Your file - Votre référence  
3BM-CAM1520

**Re: Crown-Indigenous Relations and Northern Affairs Canada's comments on the Hamlet of Cambridge Bay's renewal application for water licence #3BM-CAM1520 for municipal undertakings – Hamlet of Cambridge Bay**

## **Technical Review Memorandum**

Figure of sampling stations taken from Sewage Lagoon O&M Manual

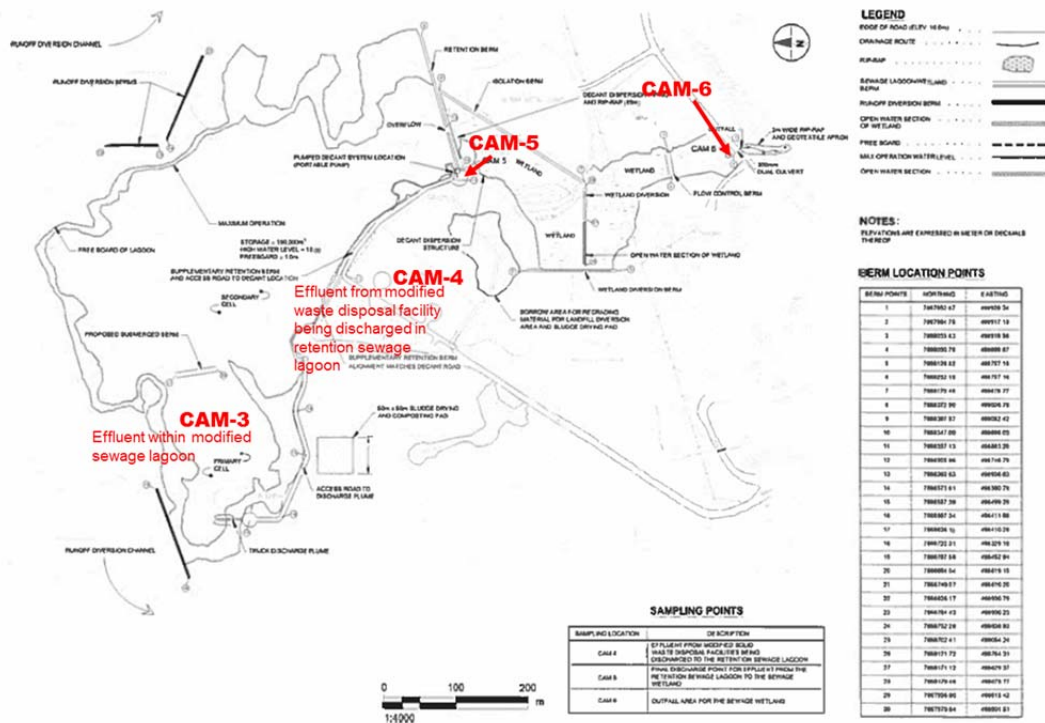
As mentioned above, the sewage and solid waste facilities in Cambridge Bay are co-located, and they share some water management features. Section 6.5 of the Solid Waste Disposal Facility Operations and Maintenance (O&M) Manual: “*surface water collecting in control ponds can be pumped into the lagoon.*” The 2018 annual reports confirms this practise is used: “*Sometime waste run-off required to pump out to sewage lagoon when snow melts or rains flooded the waste facility.*” Additionally, surface water draining from the landfill is directed via a ditch to the wetland that also receives treated sewage from the retention lagoon (personal communication, B.Pedersen, March 13, 2020). These features are illustrated in figure C-14 of appendix D in the Solid Waste O&M Manual and the figure below.

Part D Item 5 of the current water licence requires sampling at station CAM-5 and sets discharge criteria for station CAM-6. These station locations are identified in the figure above. The licensee has provided water quality results for CAM-5 in 2015, 2016, 2017 and 2018, while results for CAM-6 are available for 2015, 2016 and 2018. Four of the six samples at CAM-6 had pH values outside the 6 - 9 range set by the licence, with values ranging from 9.36-10.20. The treatment through the retention cell causes pH to increase; for 3 of 6 samples, pH is within criteria at CAM-3 in the sewage lagoon and above pH 9.0 at CAM-5, when leaving the retention cell for the same dates.

The water licence has no discharge criteria for metals. However, metal concentrations in the effluent of the waste disposal facility at CAM-4 are elevated, as might be expected from contact water at a landfill. Iron concentrations are on average 10 570 µg/L (range 322 - 24 500 µg/L) and though they are reduced in the wetland, concentrations are still high at the final discharge point CAM-6 (average 544 µg/L, range 301 - 739 µg/L). These iron concentrations are above the Guidelines for the discharge of treated municipal wastewater in the Northwest Territories and the Canadian water quality guidelines for the protection of aquatic life (CWQG-PAL) in freshwater – long term, which are both 300 µg/L. Copper is the other metal with concentrations with concentrations at the final discharge point CAM-6 (average 6.0 µg/L, range 3.4 – 12.6 µg/L) regularly above the CWQG-PAL. The guideline for copper is variable depending on water hardness, and for the samples measured it is almost always 4 µg/L. The 2015 CAM-6 samples also have elevated aluminum, cadmium and lead concentrations, but it was a single occurrence, and concentrations at CAM-4 on the same date are not elevated.

CIRNAC recommends the licensee explore options to reduce pH of the retention cell effluent to meet licence discharge criteria. Additionally, CIRNAC recommends the licensee explore options to reduce metal concentrations in landfill contact water.

CIRNAC also recommends discharge criteria be re-considered to include metal concentrations if applicable, since the effluent tested is in part from a landfill.
